***HDD PA-YO-0063.0000-RR (S-A22)***

Revised: February 6, 2017

20-INCH HORIZONTAL DIRECTIONAL DRILL  
SUSQUEHANNA RIVER  
PENNSYLVANIA PIPELINE PROJECT

SCALE: 1"=300'    DWG. NO: PA-YO-0063.0000-RRa

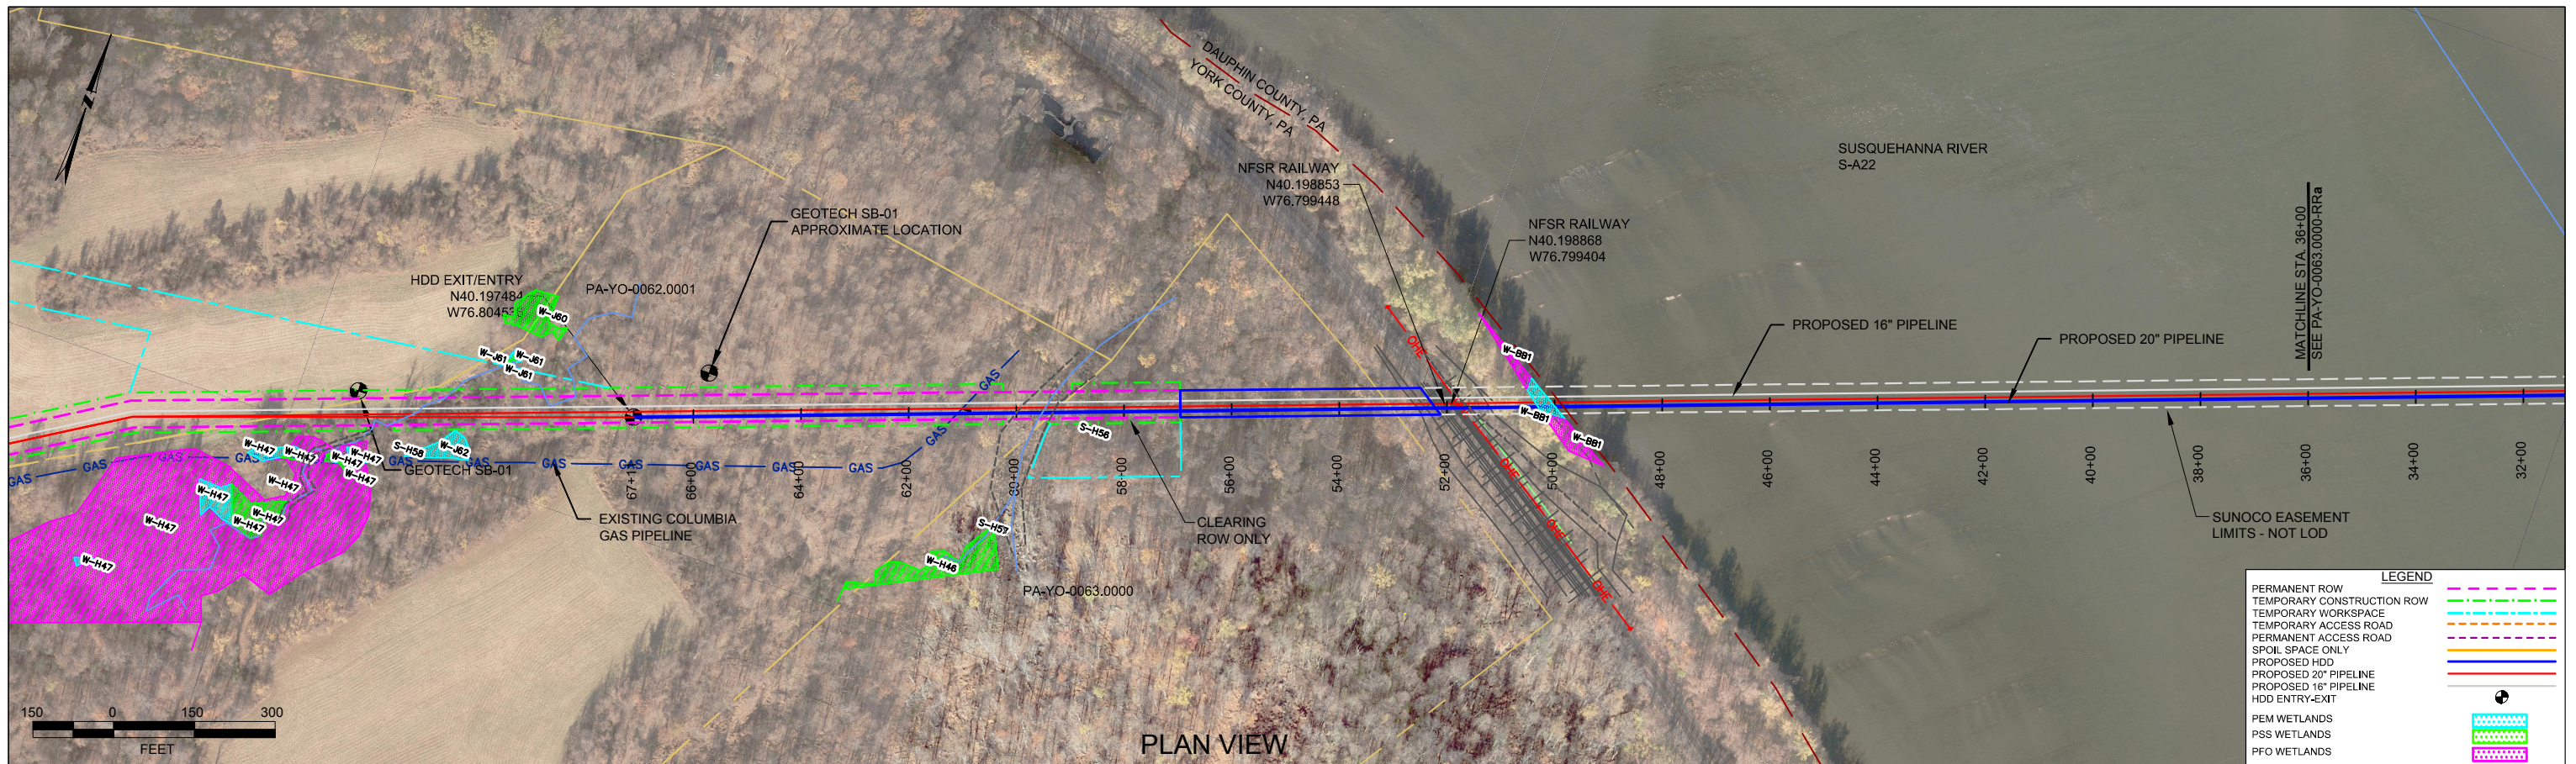
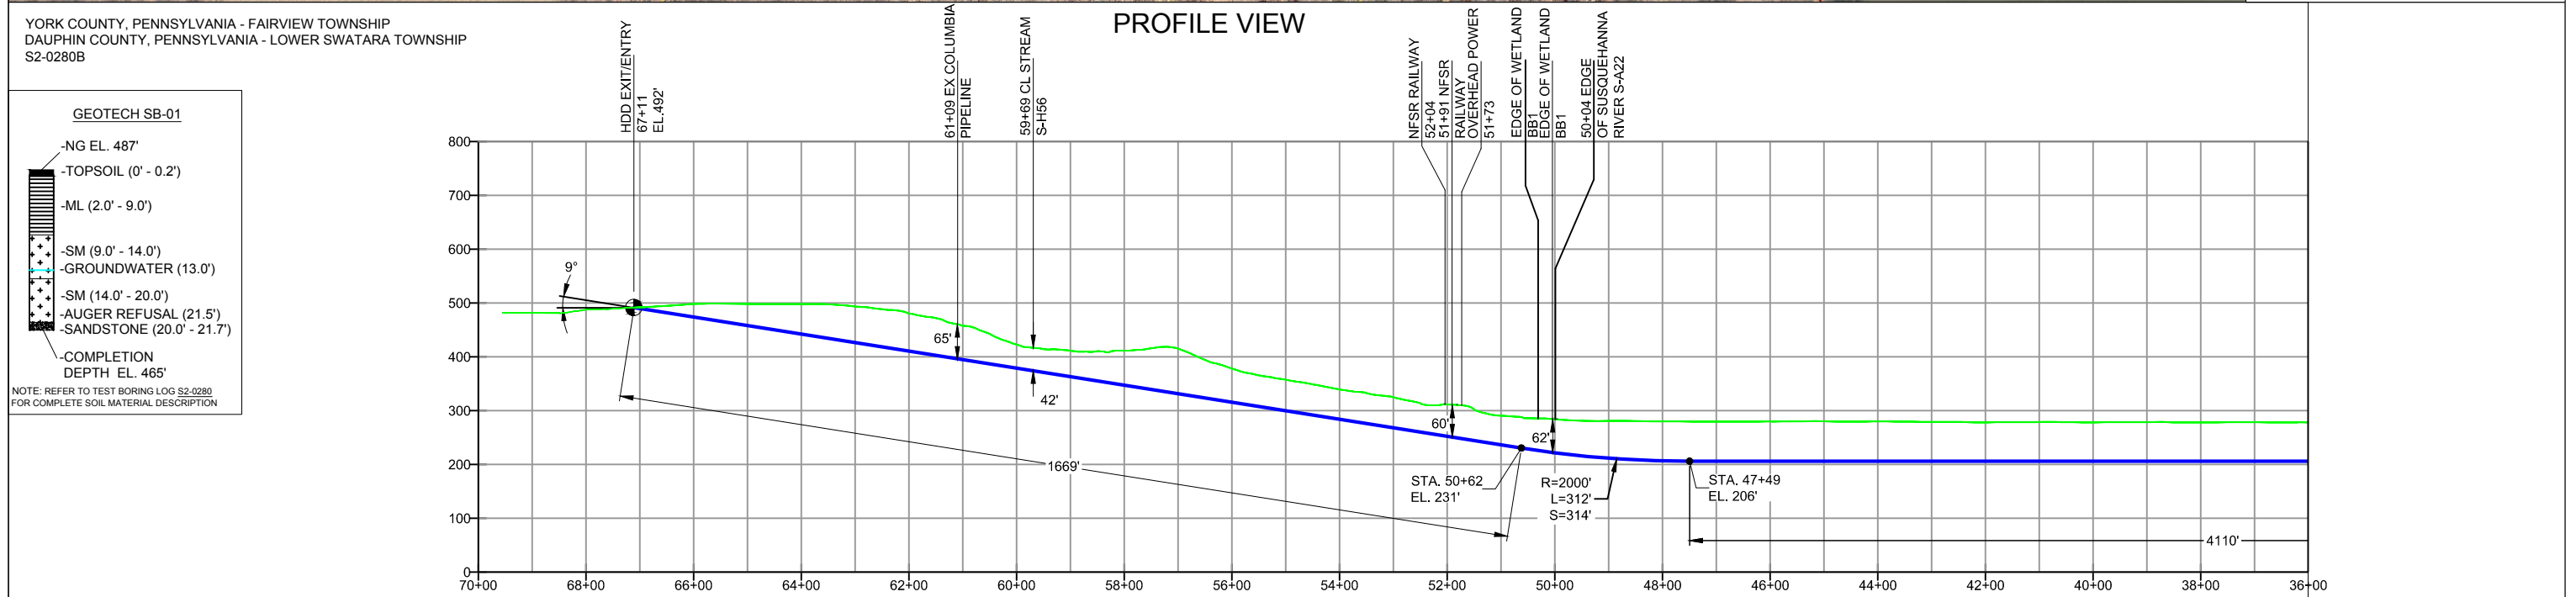
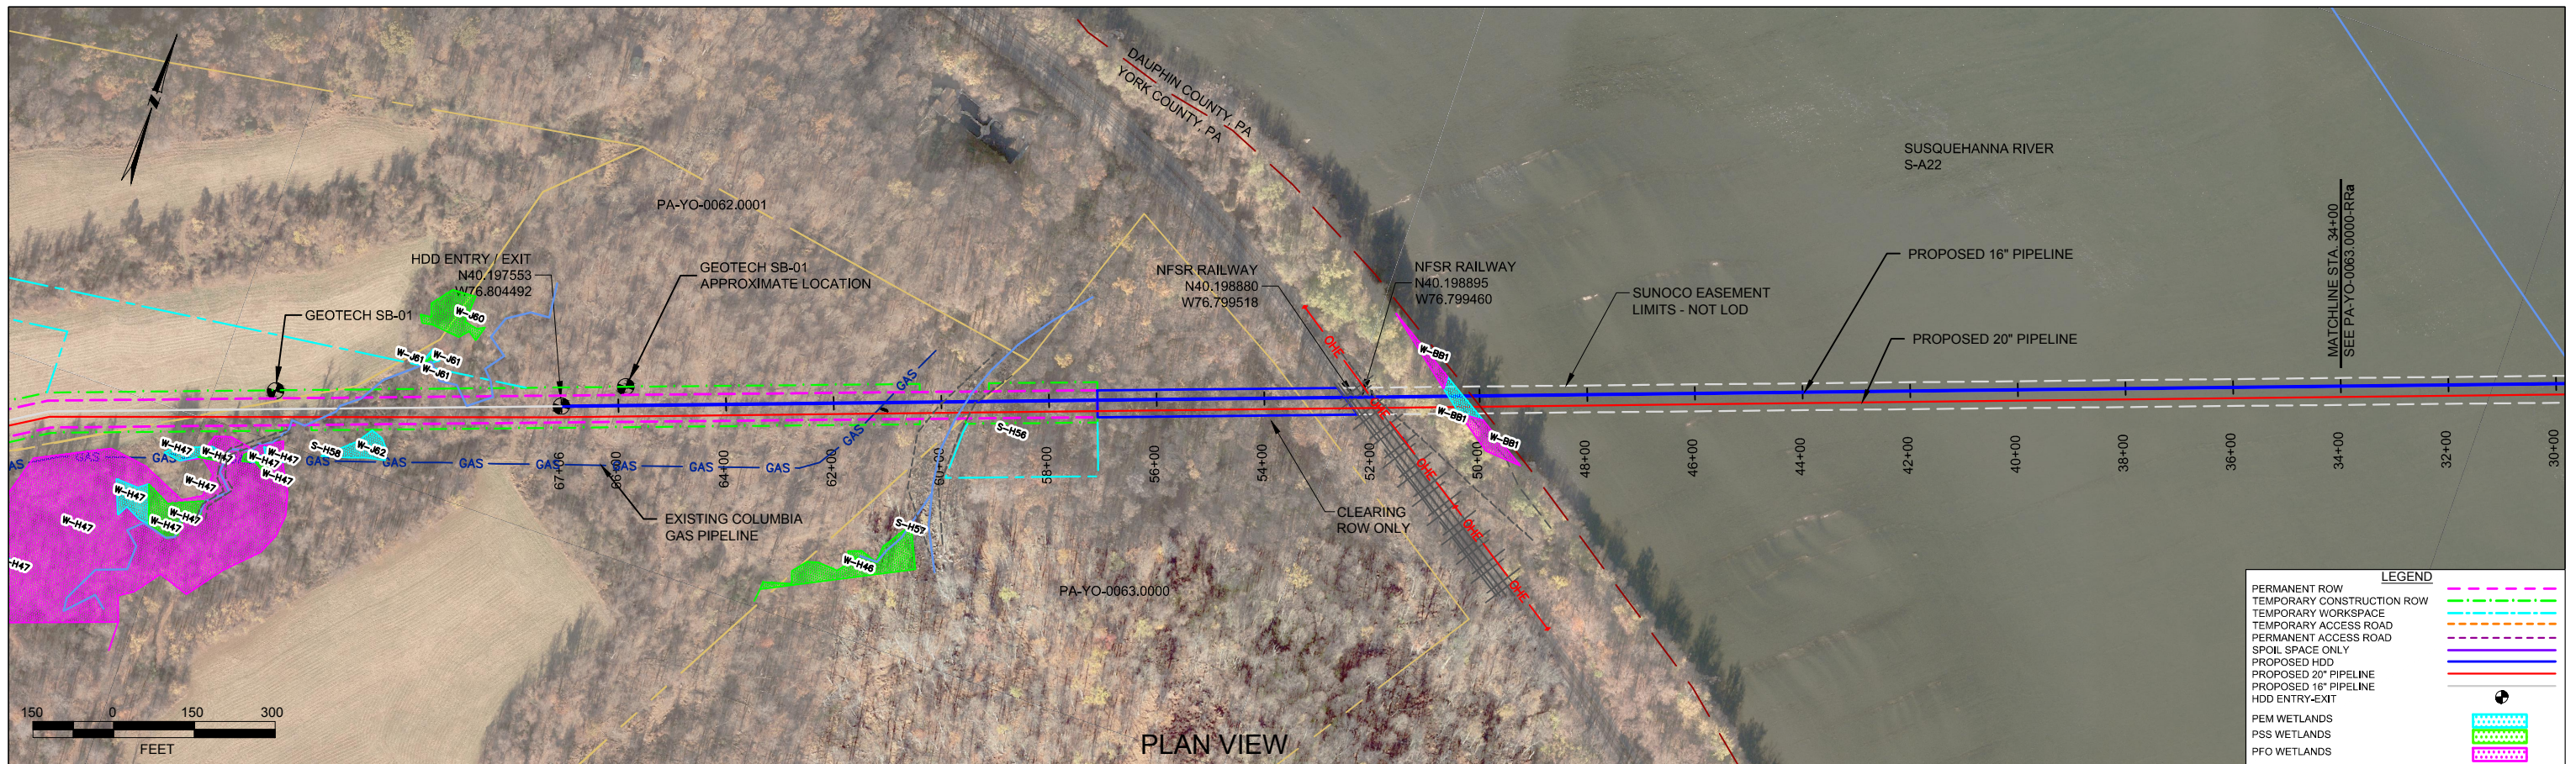
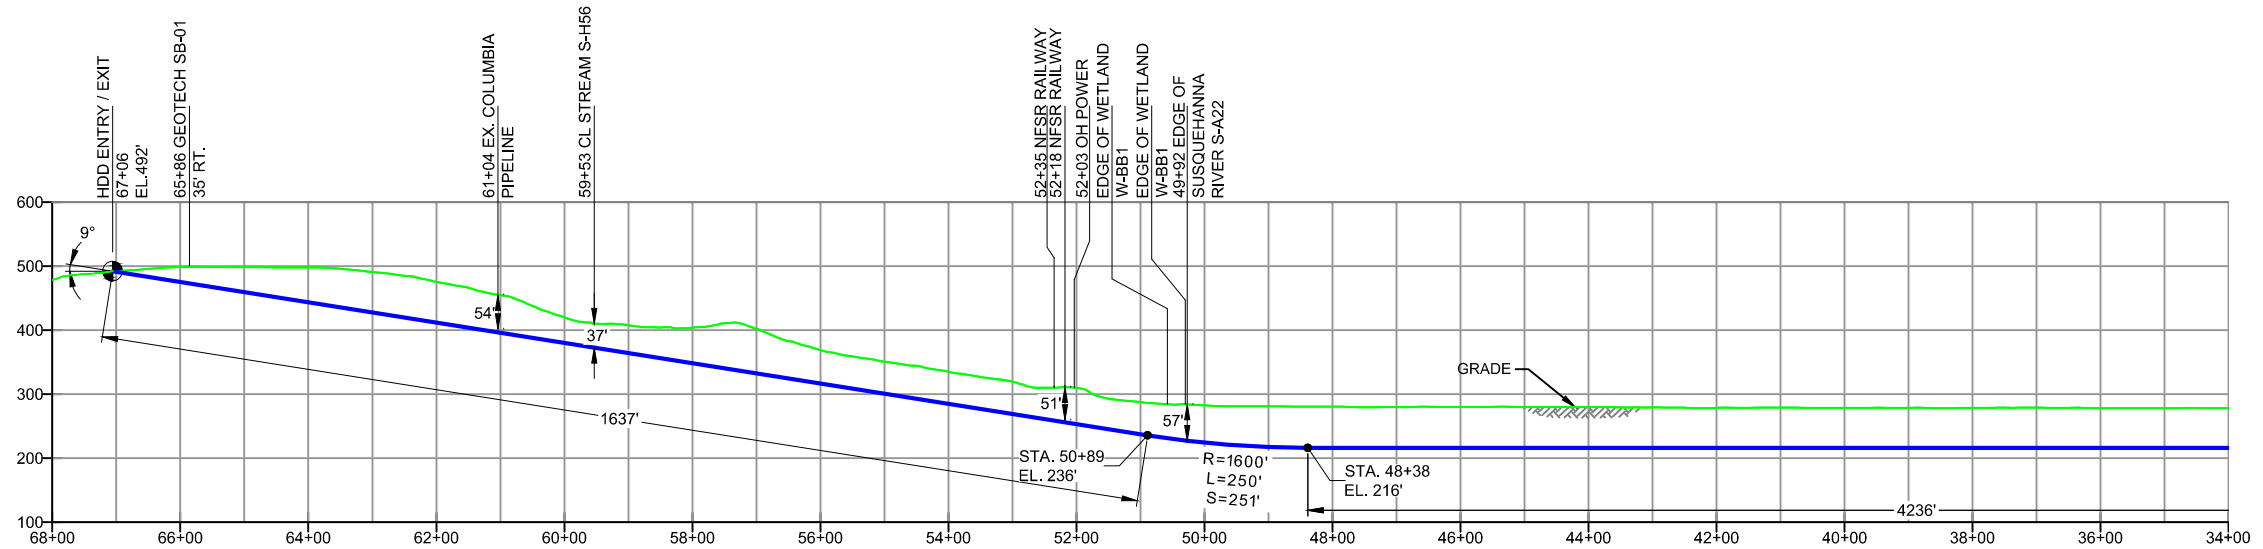
Given the design, the threat of inadvertent return has been reduced to the maximum extent practicable and in this case that threat is considered to be low. Implementing this design, along with adherence to the Pennsylvania Pipeline Project Inadvertent Return Contingency Plan will ensure inadvertent impacts, if they were to occur, are also minimized to the maximum extent.

The drill will pass 75' below the river. The geotechnical results, as well as other data points, were used to determine the entry/exit angles, and depths to pass through the best substrates while maintaining the pipe integrity (e.g., no large bends). According to the geotechnical report primary substrates being drilled through are sandstone beneath layers of silt and clays. Based on the geotechnical report and the drill profile minimal inadvertent returns are expected. Due to the river width additional inspection is recommended to observe for inadvertent returns.

The drill will enter/exit 1800 feet from the western edge of the Susquehanna River (S-A22) and enter/exit 1,050 feet from the eastern edge. The drill will enter/exit 800 feet from the western edge Stream H56 and enter/exit 5,900 feet from the eastern edge, crossing 42 feet below the stream.

REF. DRAWING		REVISIONS	
ES-4.20	TO ES-4.04	NO.	DESCRIPTION
SHEET 13	TO SHEET 2	EP3	REVISED PER PADEP COMMENTS RECEIVED 01-30-17
		3	DESIGN CHANGE - RELOCATED DRILL ENTRY/EXIT
		2	REVISED PER ENGINEERING COMMENTS
		1	REVISED PER COMMENTS FROM REI REVIEW
		0	ISSUED FOR CONSTRUCTION
